UNITED STATES PATENT AND TRADEMARK OFFICE
CERTIFICATE OF CORRECTION

PATENT NO. : 6,975,642 B2
APPLICATION NO. : 10/003959
DATED : December 13, 2005
INVENTOR(S) : Levinson et al.

Fig. 1

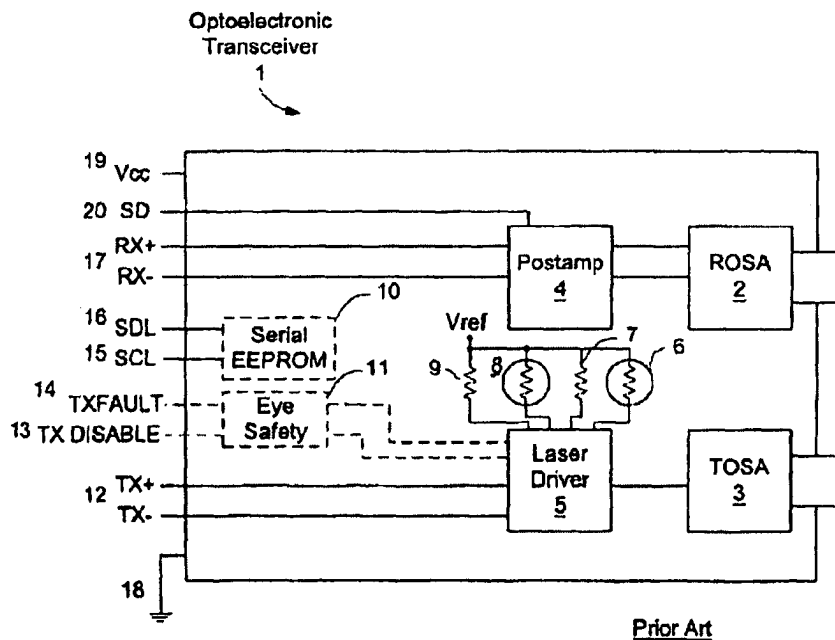
Sheet 1, replace Figure 1 with the figure depicted herein below, wherein the TX DISABLE has been labeled with --13--
